Table A-2 Changes in ASME Code Case N-660, Revision 0 for PWROG Passive Categorization

Revised Table A-2 for WCAP-16308-NP – based on NRC Feedback from March 3, 2008 Telephone Conference Call

Figure I-1
Risk-Informed Safety Classification Process

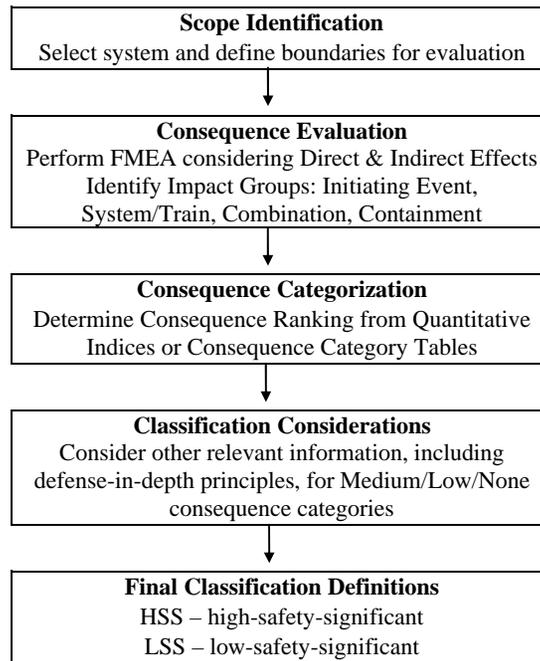
Note 1 – Figure I-1, Risk-Informed Safety Classification Process
